SIB 64 03 20 2021-10-04

CENTER CONSOLE / CUP HOLDER GETS HOT WHEN THE HEAT IS ON

This Service Information Bulletin (Revision 1) replaces SI B64 03 20 dated September 2020.

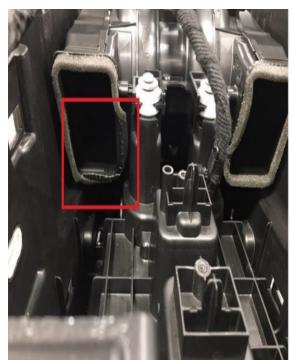
The air ducts may not be properly connected, this allows heated air to leak out in this area.

The foam material that seals between the ducts may be out of position, not held by the mounting adhesive and squashed allowing for an air leak. This leak can occur at any of these 6 junction locations:

- 1-Check foam seal material at duct connections and replace foam as needed. Ensure ducts are properly overlapped on installation.
- 2-Replace rear air ducts.

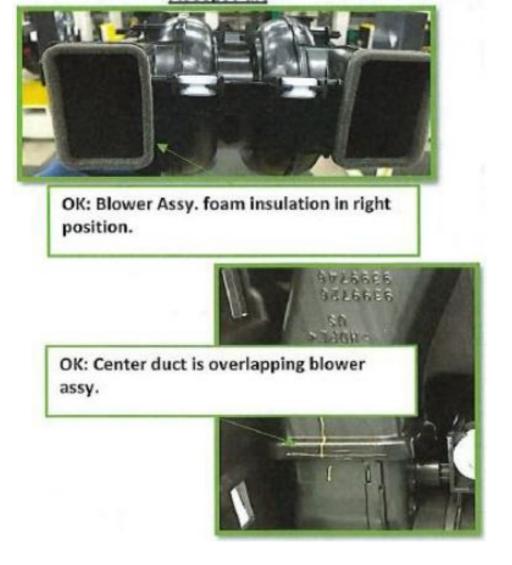
Not OK: Blower Assembly foam insulation found rolled, not positioned in correct, location allowing air to leak.

2. Check if the foam material to the next connecting piece is correctly installed. If damaged install a locally sourced, one side self-adhesive

HVAC foam. (The foam seal comes assembled on new parts and is not available separately in the BMW parts system).

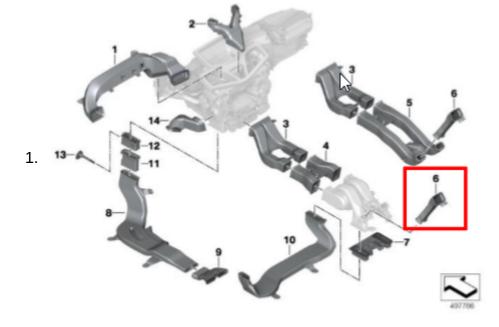
To improve interior acoustic levels and circulate some air into the console, the rear air ducts with part number 51 16 9 399 775 (left side) and 51 16 9 399 776 (right side) are utilized on the G07 and optionally on the G05. These ducts have a hole that is covered in fleece material.

To maximize heat reduction within in the center console, the rear air ducts with part number 51 16 9 399 775 (left) and 51 16 9 399 776 (right) **must be replaced in all cases** with base model rear air ducts with part number 51 16 6 833 469 (left) and 51 16 6 833 470 (right).

NOTE: By installing the base model rear air ducts with part number 51 16 6 833 469 (left side) and 51 19 6 833 470 (right side) these fleece cutouts are removed maximizing the heat reduction in the center console. **The base ducts may impact acoustics of rear HVAC.**
